Re: United Heckathorn Superfund Site, Richmond, California

This technical memorandum presents a review of the Draft Focused Feasibility Study (Draft FFS) recently issued by the U.S. Environmental Protection Agency (USEPA) for cleanup measures at the Former United Heckathorn site in Richmond, California (Site; Figure 1). The Draft FFS presents the development and analysis of remedial alternatives for marine sediments that continue to be impacted by various contaminants of concern in the Lauritzen Channel (referred to herein as "the Channel"), following an initial cleanup attempt in 1996 and 1997.

Figure 1
Site Location Map
Engineering Review of Draft FFS
Former United Heckathorn Site, Richmond, California

Figure 8.
Example Remedial Footprint
SWAC Target = 400 ppb
Carbon Efficiency = 80%

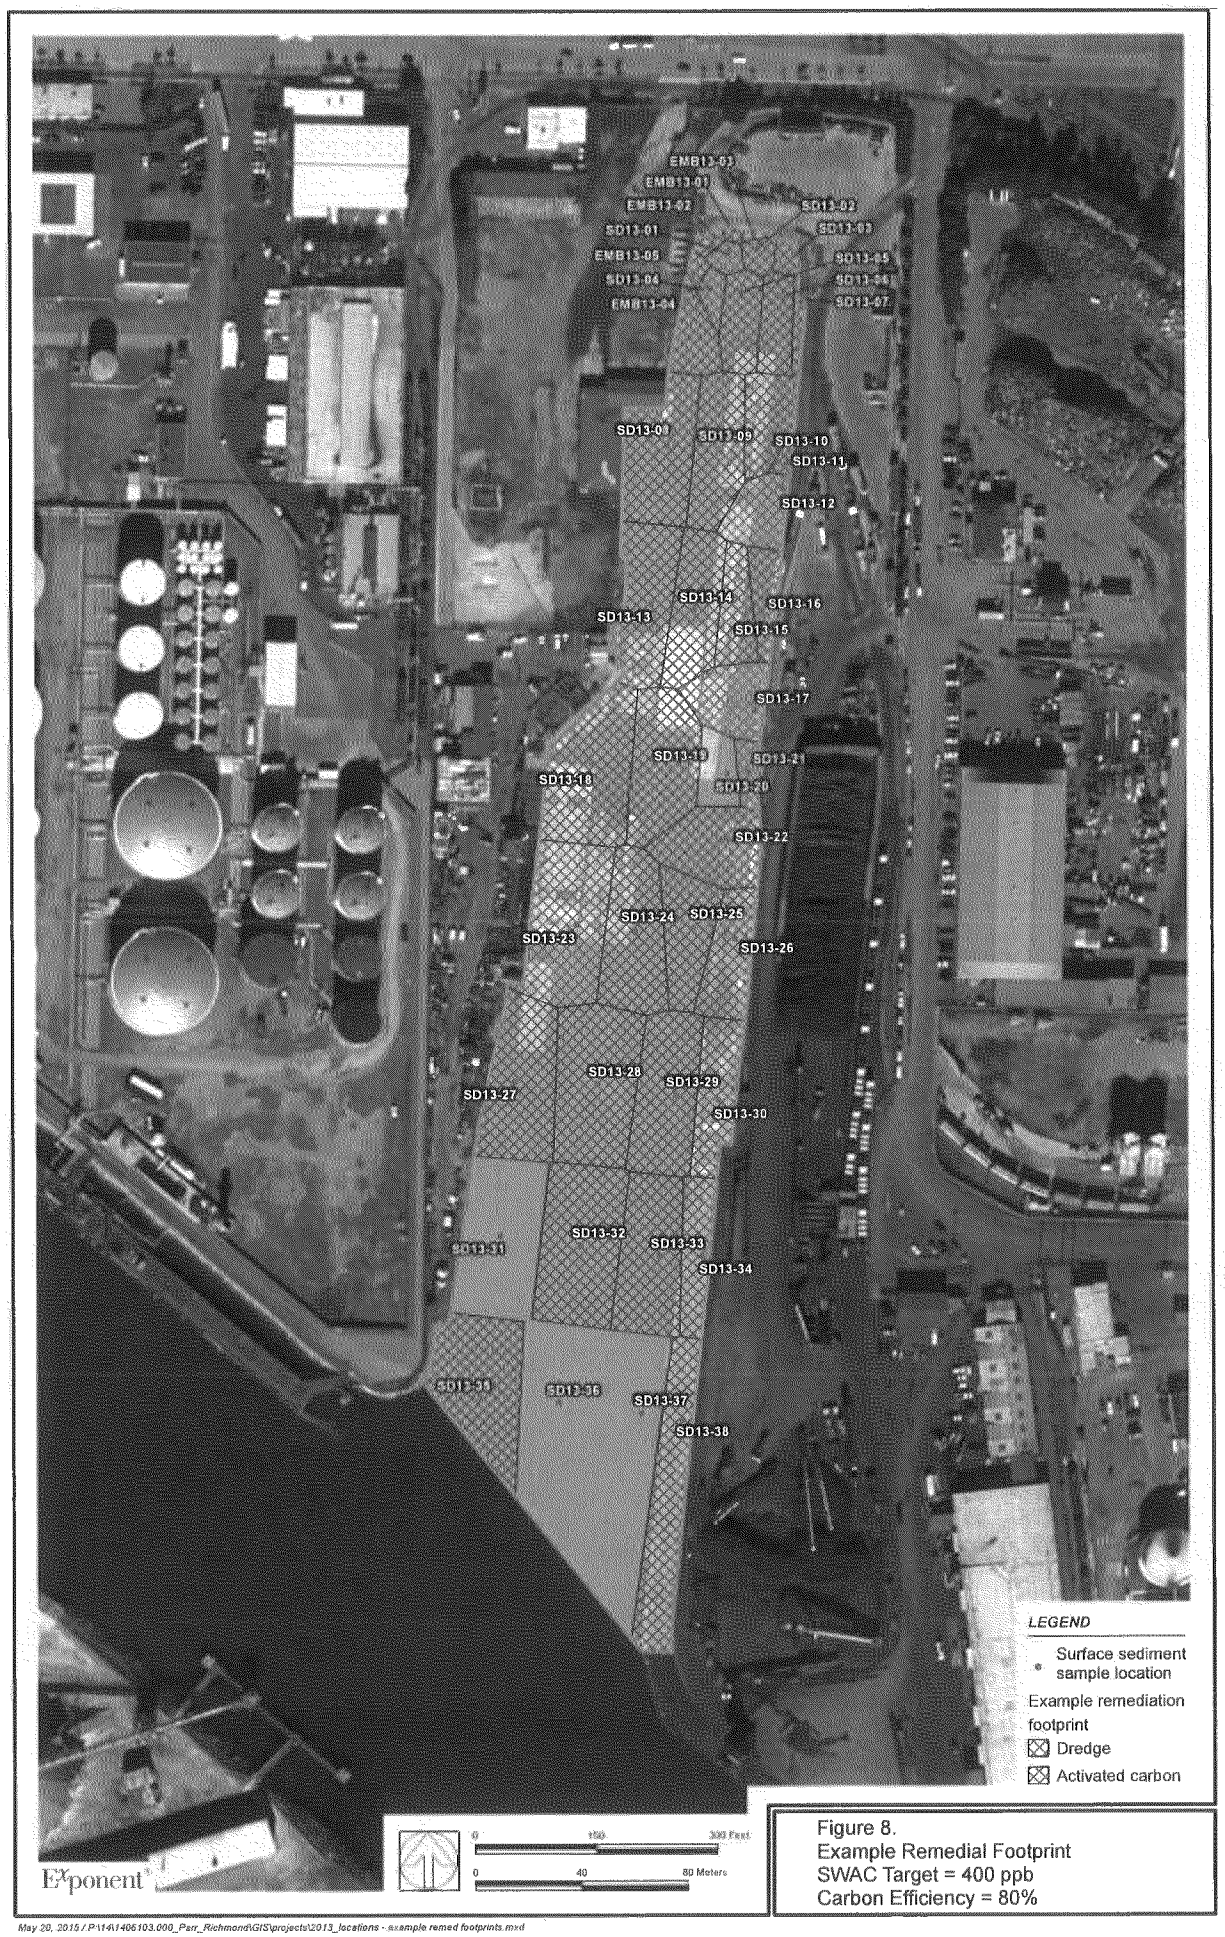
assuming carbon amendment would reduce exposure by 95%. The activated carbon amendment footprint is approximately 0.8 acres in size. Figure 4 illustrates the protective remedy if carbon amendment efficiency is reduced to 80%, resulting in a slightly increased carbon treatment footprint of 1.1 acres. At this target SWAC level, the cleanup footprint is not very sensitive to carbon performance.

Figure 2
Existing Bathymetry Map
Engineering Review of Draft FFS
Former United Heckathorn Site, Richmond, California

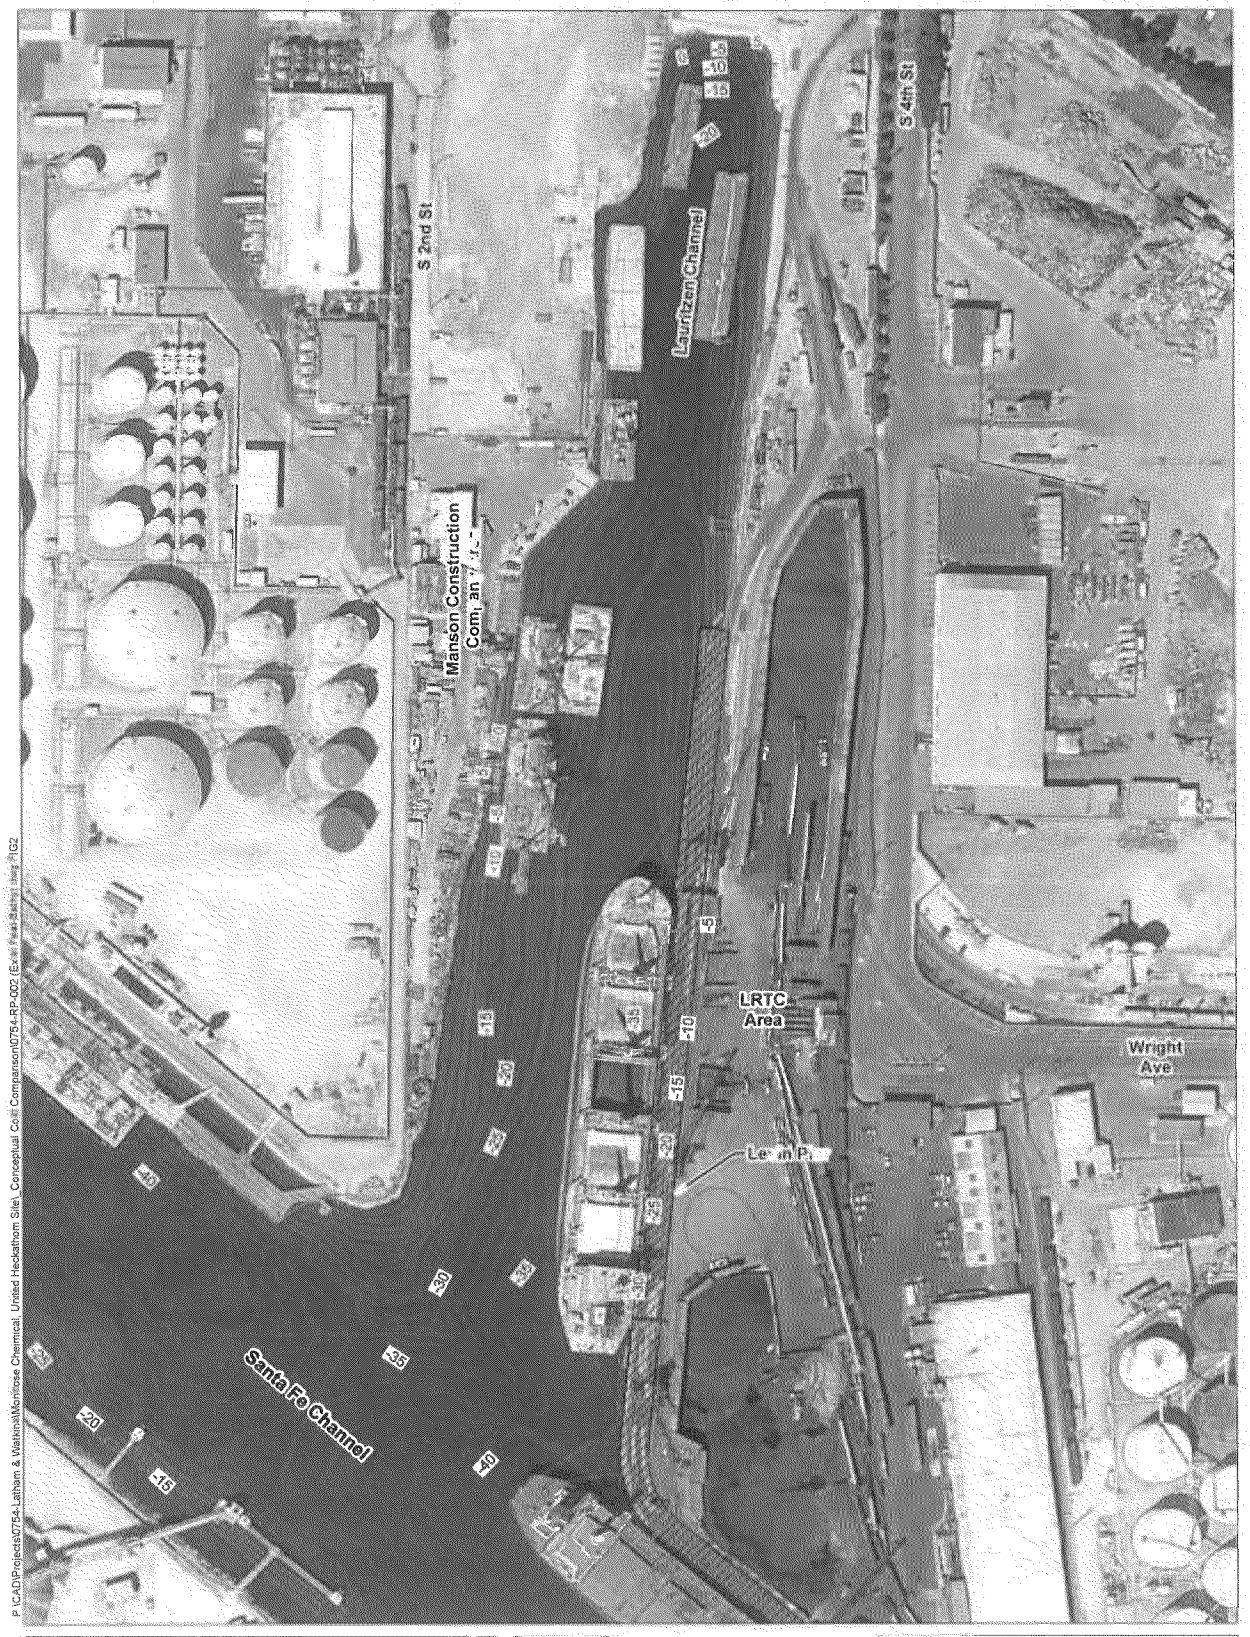
As the Draft FFS notes, the Lauritzen Channel sees a variety of ongoing industrial uses and vessel traffic. The East side of the Lauritzen Channel is used by the Levin Pier and LRTC facility (as shown on Figure 2), where relatively deeper water exists; contours near the Levin Pier reach depths of -35 to -36 feet mean lower low water (MLLW). A significant portion of the Lauritzen Channel's chemically impacted sediments are present in this area of deep water, to thicknesses of approximately 5 to 6 feet, meaning that this area would likely contribute approximately 40,000 cubic yards to the estimated dredge volume. Similar considerations appear to apply to the West side of the Channel, where shallower water depths are present, ranging from approximately -10 feet to -25 feet MLLW and sloping gradually deeper away from the shoreline (Figure 2). This area is currently utilized by Manson Construction for equipment berthing and storage.

Figure 3
Areas of Constrained Dredging in Lauritzen Channel
Engineering Review of Draft FFS
Former United Heckathorn Site, Richmond, California

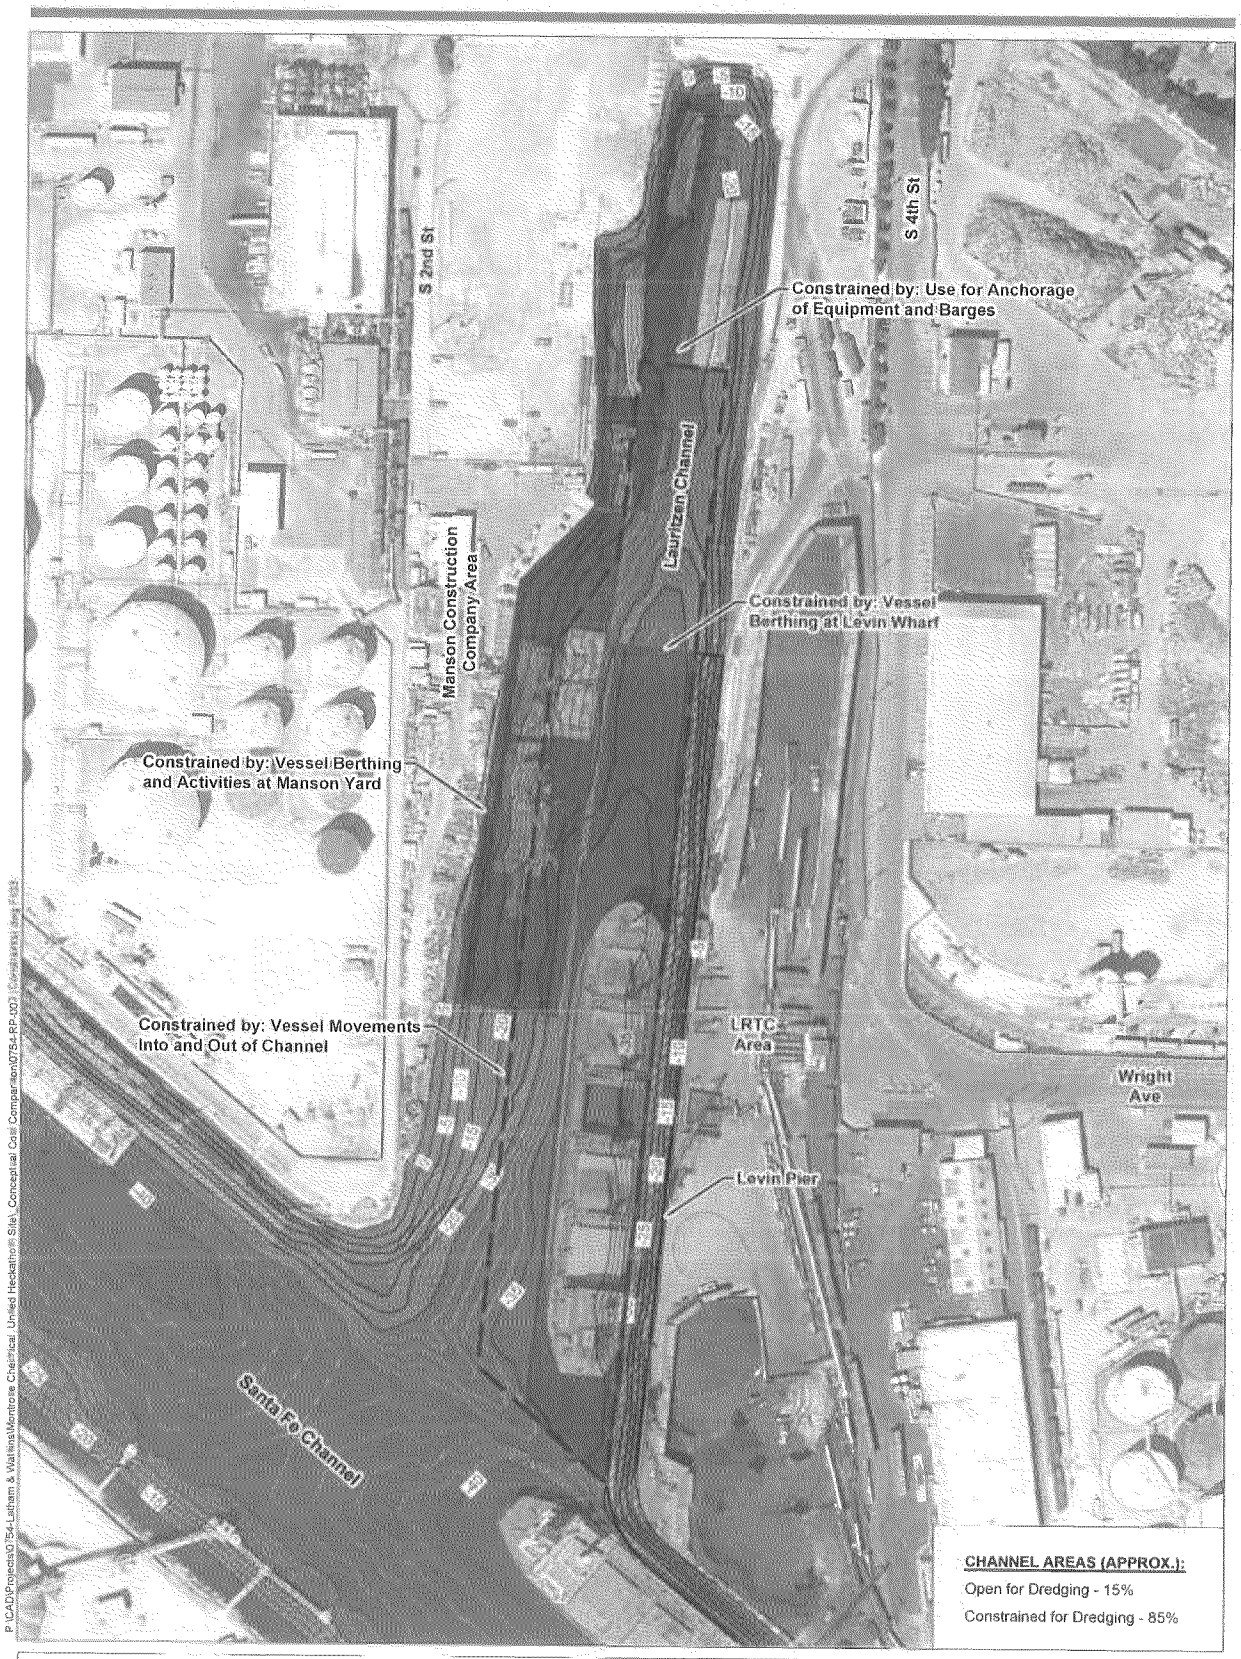
As is shown on Figure 3, constraints on the dredging process will result from a number of factors, including:

Figure 4
Conceptual Dredging Plan
Engineering Review of Draft FFS
Former United Heckathorn Site, Richmond, California

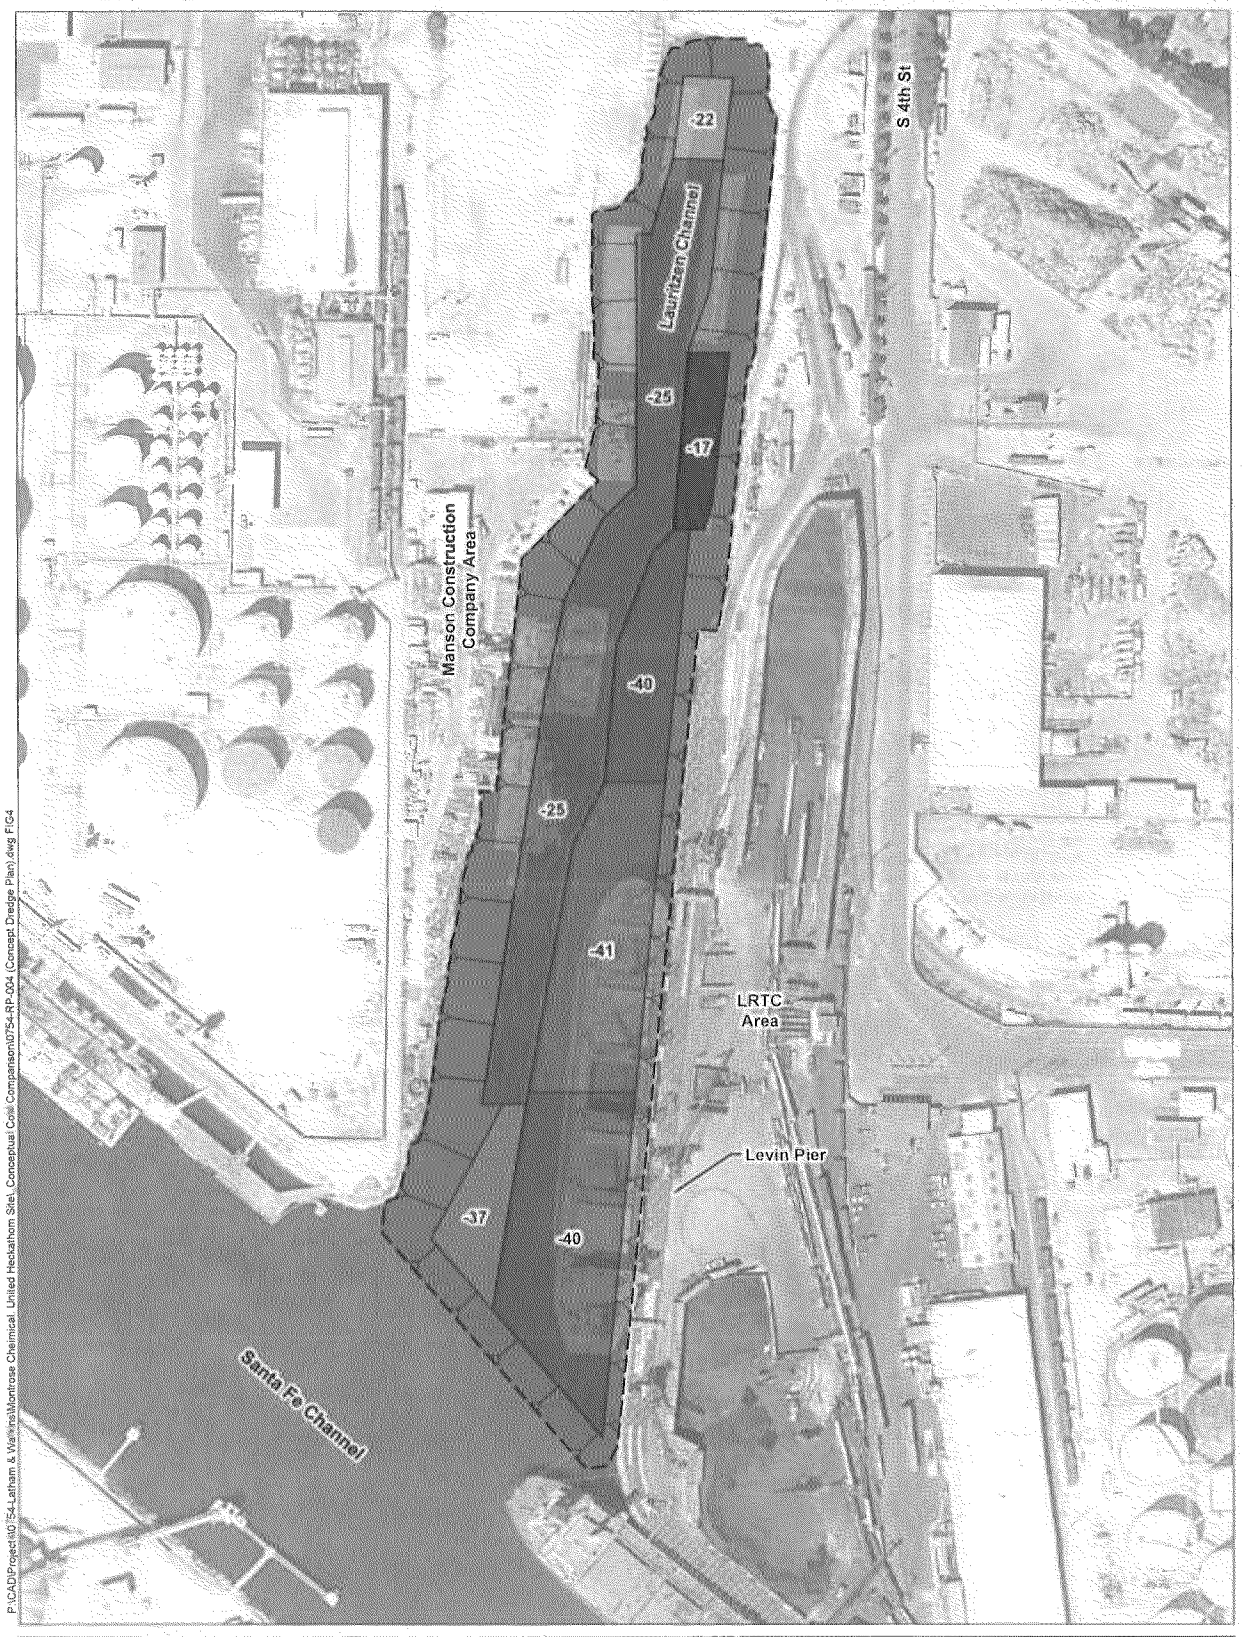
The conceptual dredge plan shown on Figure 4 was developed by identifying the required depth of sediment removal at each of the 2013 sediment cores (based on the presence of YBM and extent of cleanup criteria exceedances for dieldrin and DDT), and selecting a representative target depth for dredging in various areas of the channel. Due to localized irregularities in the sediment thickness and target depth, and the need to divide the project area into manageable subunits, it is necessary to establish target dredge depths that are frequently deeper than the YBM depths indicated at individual core locations. Dredging depths are frequently determined by taking the necessary depth of sediment removal, and rounding up to the nearest foot deeper.

The conceptual dredge plan shown on Figure 4 results in the following approximate dredging volumes for the full extent of the Lauritzen Channel:
